Why switch to new DSLC-2XT & MSLC-2XT ?

Clemens - 2023-04-19 - MSLC-2

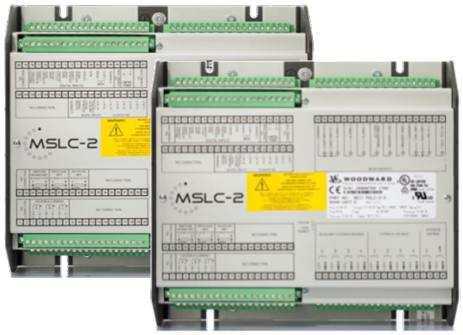
8440-1878 DSLC-2-5
8440-1978 DSLC-2-1

8440-2299 DSLC-2XT

8440-1877 MSLC-2-5
8440-1977 MSLC-2-1

8440-2298 MSLC-2XT

- same form factor
- same mounting dimensions
- only one part number for DSLC-2 and MSLC-2XT
- up to 690VAC direct sensing
- ../1A & ../5A current sensing
- Drop-in Replacement
- Class 1 kW sensing
- Higher galvanic isolation of PID outputs
- One additional ETH-C port
- Interoperable with old DSLC-2/MSLC2
- Manuals & configuration files stored on control
- USB configuration
